## **ENVIRONMENTAL IMPACT ASSESSMENT KHMELNITSKY 2/ROVNO 4**

Report to the  
Austrian Government

Vienna, October 1998

Figure 4.1: Deposition of Cs-137 [kBq m<sup>-2</sup>] from a hypothetical BDBA in Rovno NPP. A geographical grid with 10° resolution and state boundaries are plotted for orientation

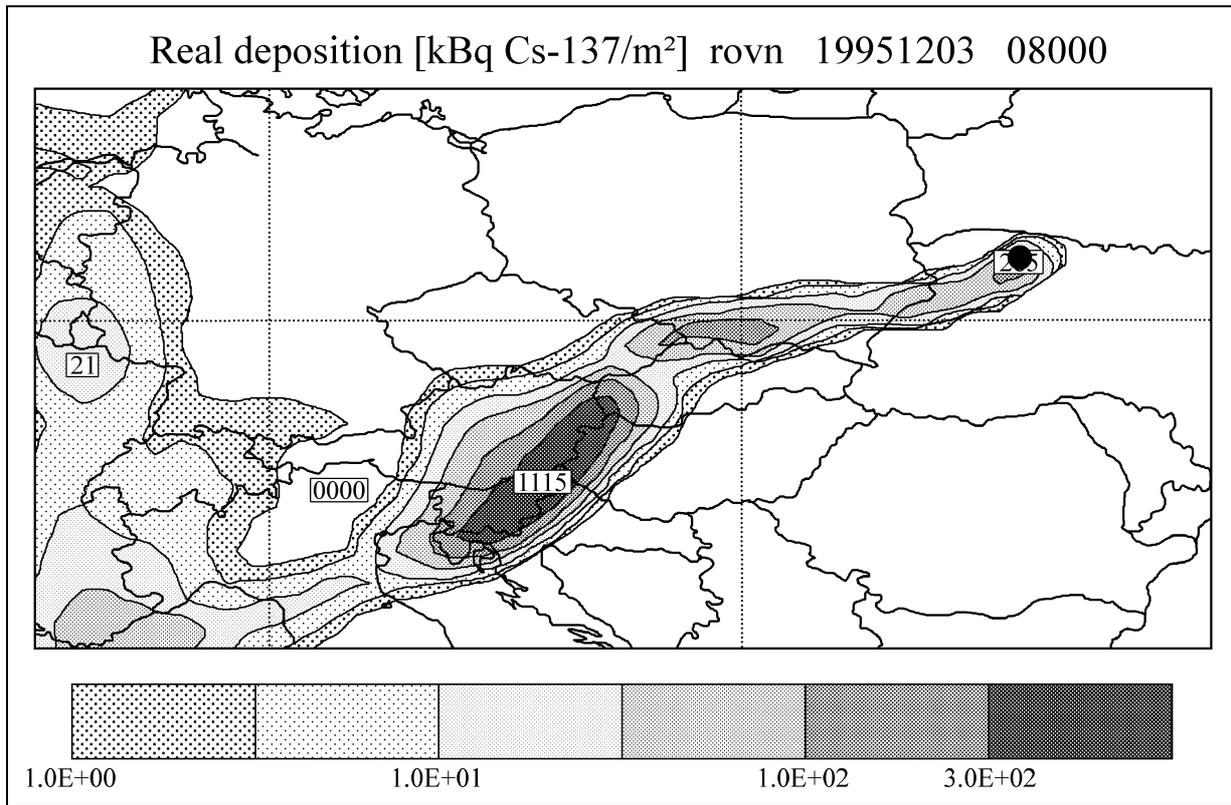
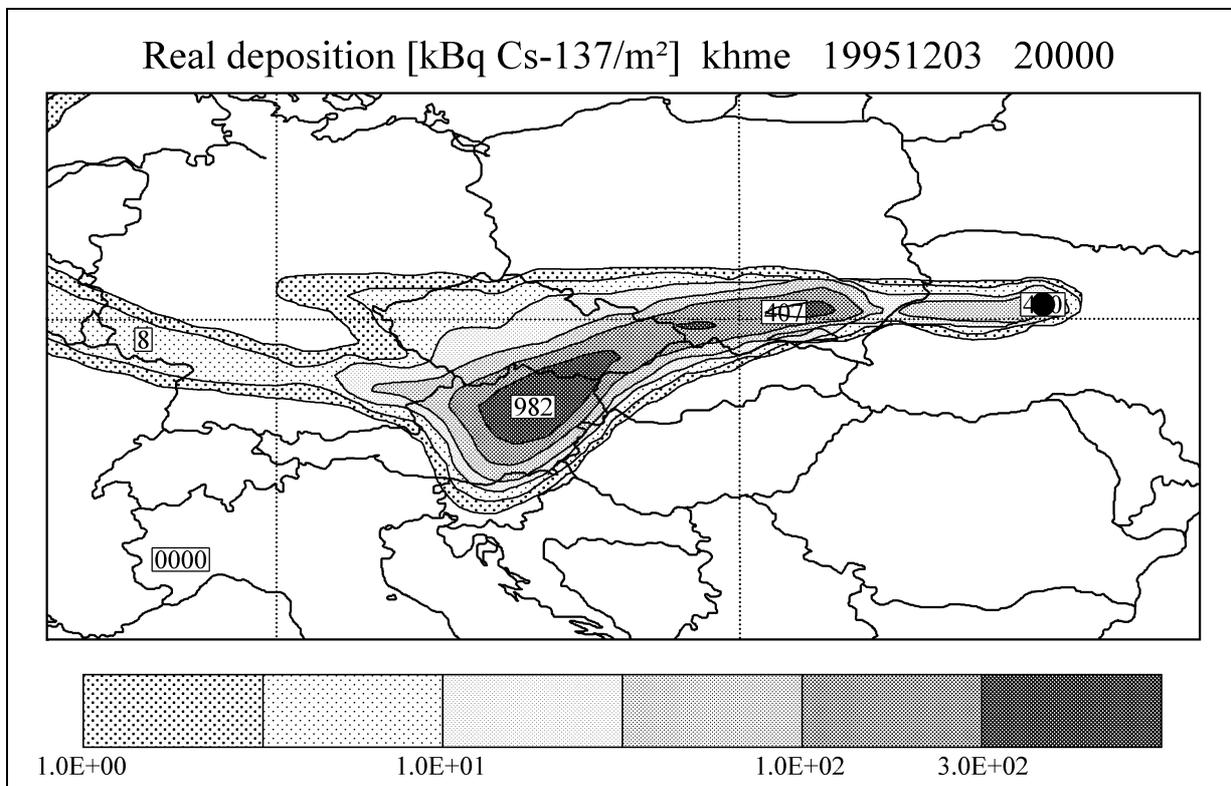
Figure 4.1. and 4.2 show the resulting deposition pattern. The track of the contaminated air is clearly visible. In addition to the main maximum in Austria, there are secondary maxima in southern Poland and close to the NPP. As already mentioned, the size of the grid does not allow for a realistic resolution of the maximum near the site. In reality, it will be smaller but with higher values.

The results of this calculation indicate that there is the possibility that an accident at Rovno or Khmel'nitsky NPP would contaminate not only regions in Ukraine but also several regions in Europe, as it happened in May 1986 after the Chernobyl accident. The contamination maxima could be even higher as 1986. For the Eastern part of Austria the calculation resulted in values up to approx. 1000 kBq/m<sup>2</sup>contamination with Cs-137 (which is about 5 times the highest values measured in Austria in 1986).

Figure 4.3: Flight corridors in the Ukraine

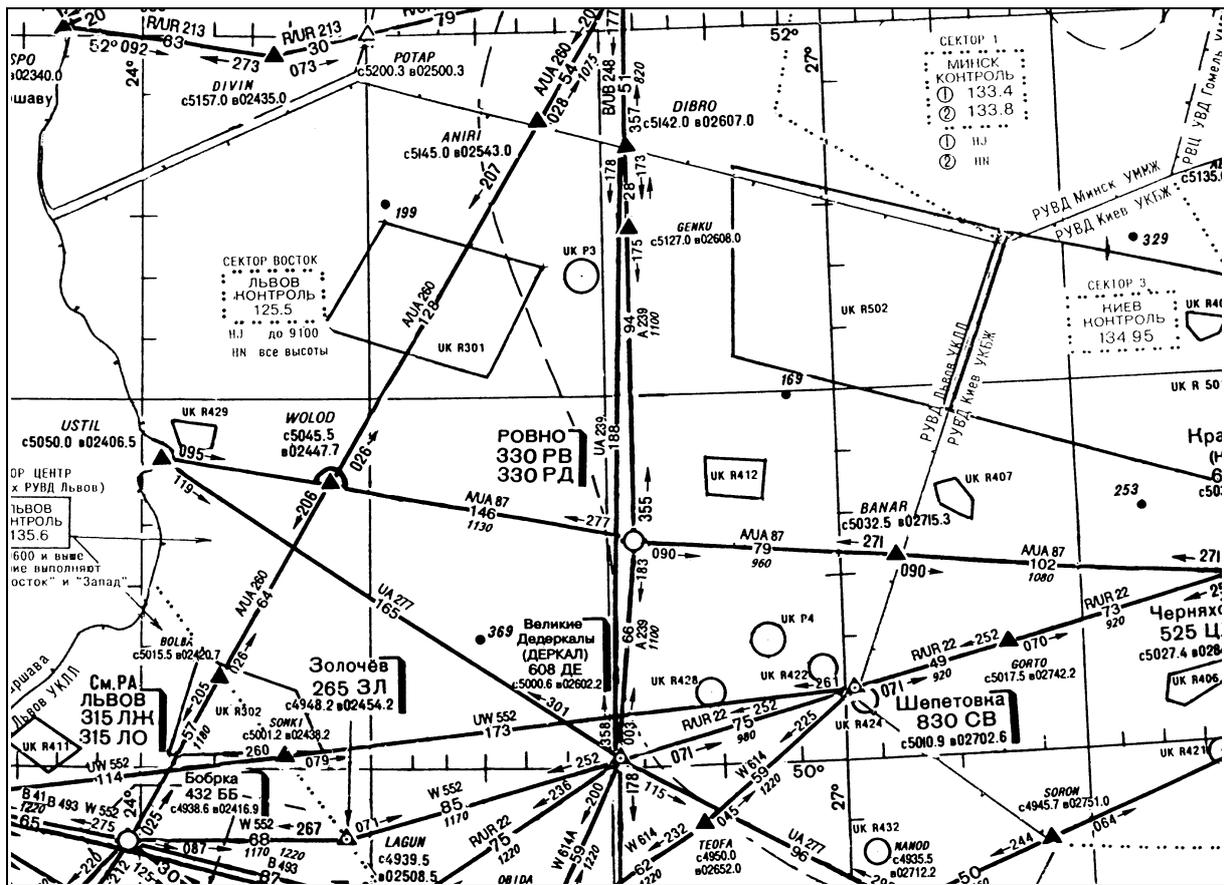
On page 3.12 it is mentioned that there are various industrial enterprises within the 30 km zone around Rovno NPP. According to information received from the regional administrations there were no facilities within the 30 km zone with a probable hazard of fire and explosions. On the presented maps there are no factories marked and there is no further information about the type of production in the surrounding of the plant presented in the EIA. The lack of information is the same where transport is concerned. The EIA does not inform about any influence by traffic, since neither transports of hazardous materials on the railway near the Rovno NPP, nor the regular flight corridor which is located in the immediate vicinity are considered (distance to the NPP 10 km, minimum flight height 1100 m). This is an important deficiency of the EIA.
